Release Notes MobiMed Smart v4.2.18

Software Article Number 490210972 (Software Build No Release-4.2.18.0_20161118.1)

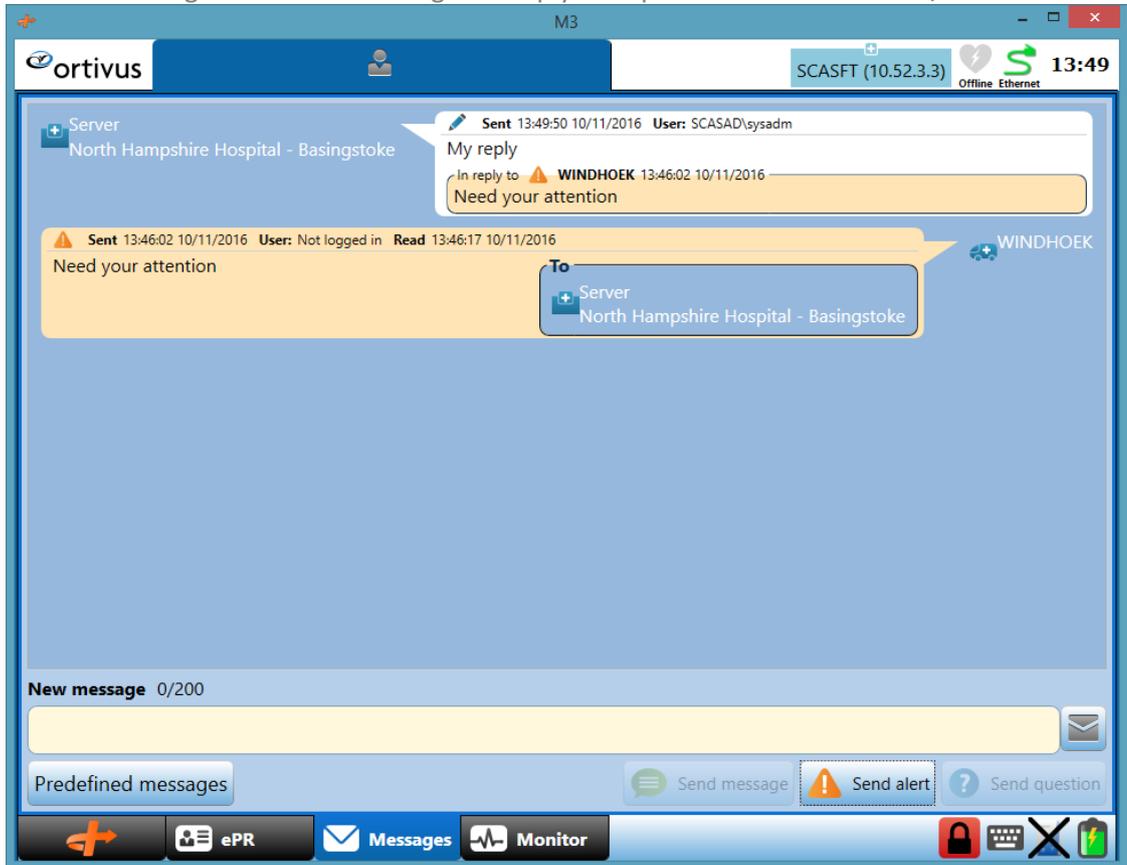
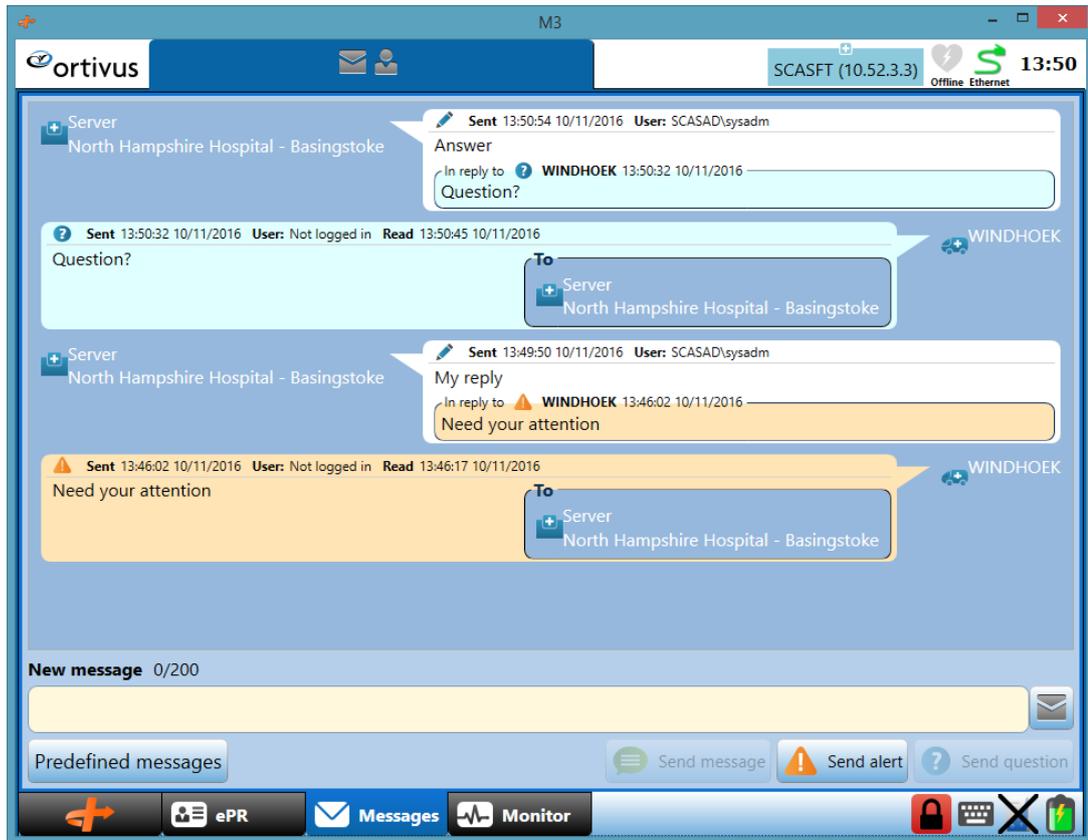
- 4.1->4.2 Medication window has been changed, route and unit no longer available in swedish eprs. (6755)
- Alerts and Questions messages having a comment could be displayed more clearly (6969)

- We have made some improvements to the message view. The answers to messages are displayed as separate entries also the user who wrote the message is now always displayed.

- The report message control has also been updated to contain the answers as it was previously missing in the reports.

- The Pen icon signals that the message is a reply to a question or alert. In CWS/PU:
